AMENDED DRAWING

Mr & Mrs Watson The Courtyard Sweeming Lane Little Fenton LS25 6HF Proposed Plans & Elevations scale 1:100 at A2 16/03/2021 drwg. no.2781-02-01E

Proposed Ground Floor Plan

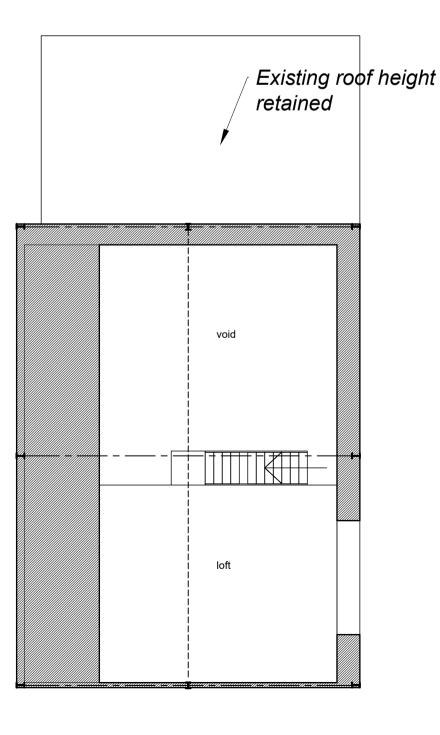
Principle differences between Approved and proposed.

1.	Proposed new block-work inner leaf built behind
	existing retained block-work with insulation between.
2.	Plan internal layout changed to 'open plan'.
2	Mazzaning/left floor added

- 3. Mezzanine/loft floor added.
- Roof over Kitchen roof level retained. 4.
- Floor to be level throughout and external levels 5. adjusted.
